INFORMATION LETTER 206-05-92

SUBJECT: FILTER 50-075-1, INSPECTION AND RECALL OF

Figure 1. Filter 50-075-1 Physical Difference

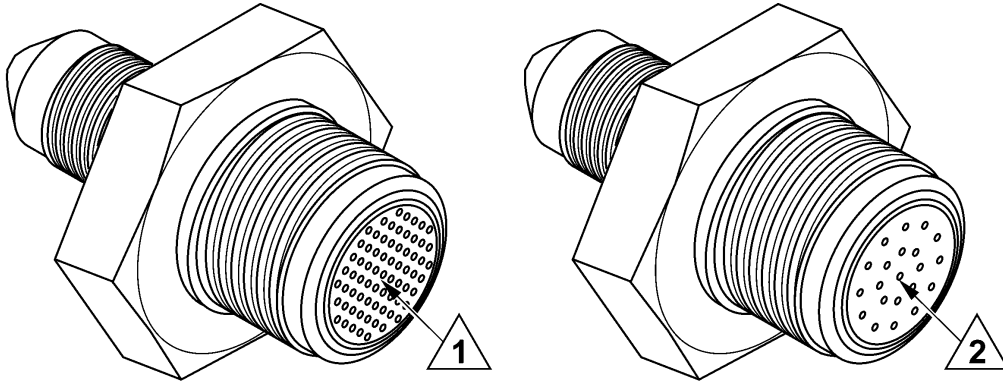
This information letter is issued to report that in some filter units 50-075-1, the screen portion of the filter was not manufactured with the correct number of holes. Testing has confirmed this condition is not detrimental to the normal operation of the transmission and freewheel oil system. However, Bell Helicopter recommends that filter units with an incorrect hole pattern be identified and replaced.

To identify the configuration to be removed from service, examine the screen hole pattern (refer to Figure 1). Replace any unacceptable filter unit at your earliest convenience.

- 1** Acceptable hole pattern. A minimum of 65 holes are required.
- 2** Unacceptable hole pattern to be removed from service.

Bell Helicopter will supply parts necessary to perform this task, consisting of packing M83248/1-906 and filter 50-075-1, at no charge. This credit is available for non-compliant filters that are installed or in stock.
